PLATTING BOARD AGENDA

STAFF REVIEW AND RECOMMENDATIONS
PUBLIC HEARING
JANUARY 19, 2023

PRELIMINARY PLAT: STELLA RIDGE MSP
LEGAL DESCRIPTION: SEC 18, T18N, R01E, SEWARD MERIDIAN AK
PETITIONERS: JERRY HARMAN
SURVEYOR/ENGINEER: HANSON LAND SOLUTIONS
ACRES: 60.00 ± PARCELS: 48
REVIEWED BY: MATTHEW GODDARD CASE #: 2020-098

REQUEST: The petitioner is requesting to bring the approved **STELLA RIDGE MASTER PLAN** back for alterations. The original master plan was approved on April 1, 2021. The petitioner is proposing to remove the right-of-way between E. Pamela Drive and E. Harman Loop, and change this to a three phase master plan. The petitioner is applying for a variance to block length for proposed block 3. The proposed master plan contains 60.00 acres +/- . The property is located south of the Little Susitna River, west of N. St Herman Street and directly north of E. Pamela Drive; within the SW ¼ Section 18, Township 18 North, Range 01 East, Seward Meridian, Alaska.

VICINITY MAP

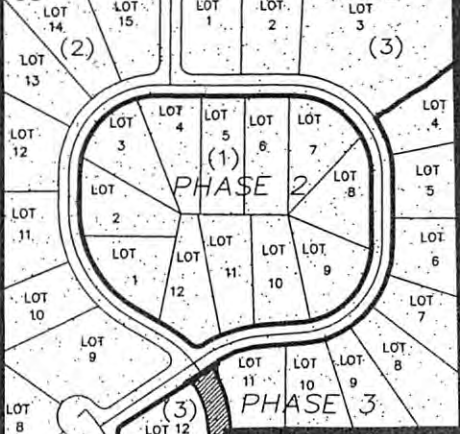
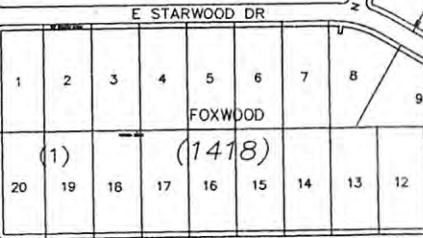
Right of Way to be removed from master plan

ADT EXHIBIT MAP

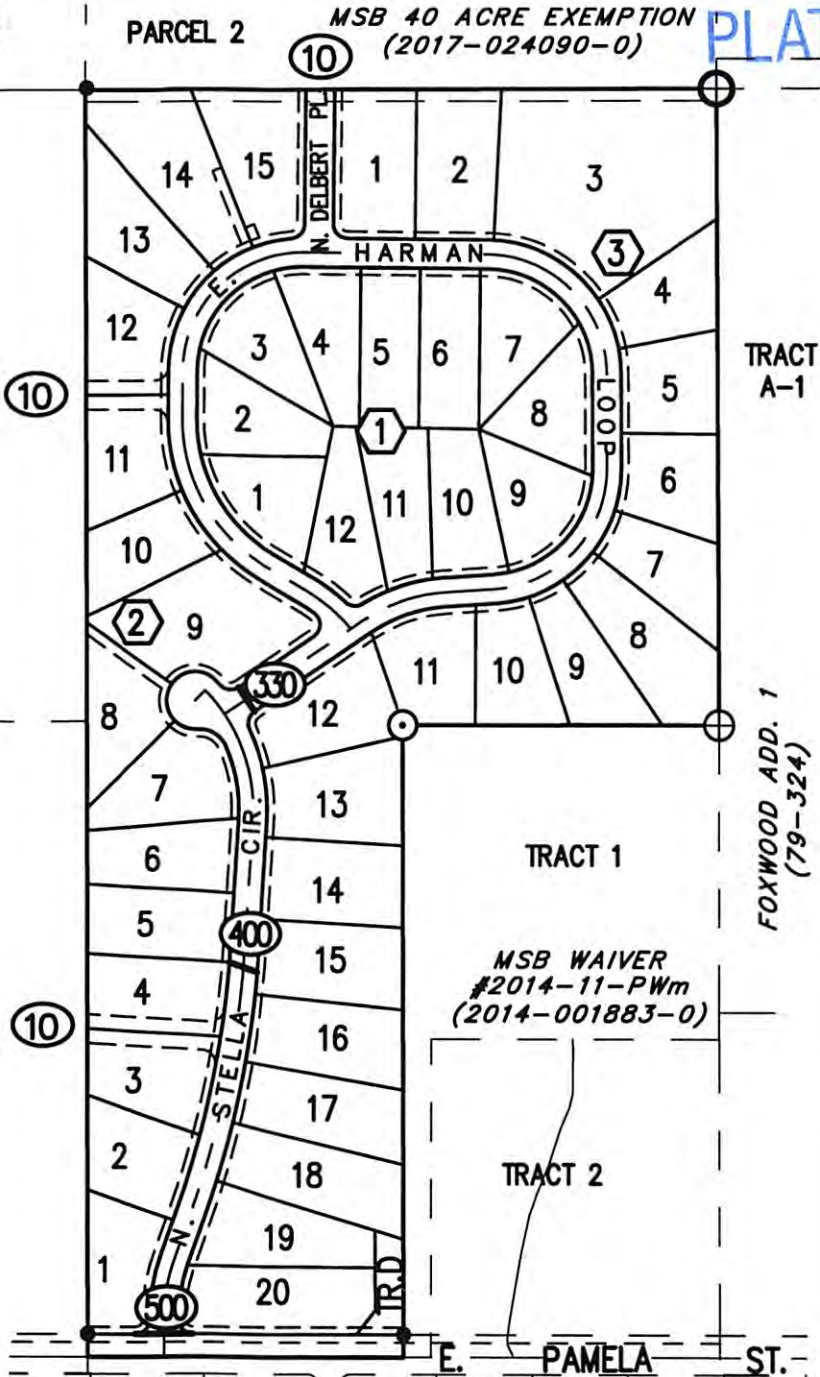
Variance Request: The petitioner has submitted a request for a variance to MSB 43.20.300(A) Block Length (**Exhibit B**).

The proposed block of lots will exceed the typically allowable block length of 3,000' by approximately 313'. No appreciable change to the provision of maintenance and safety services would be realized because the additional length is so short.
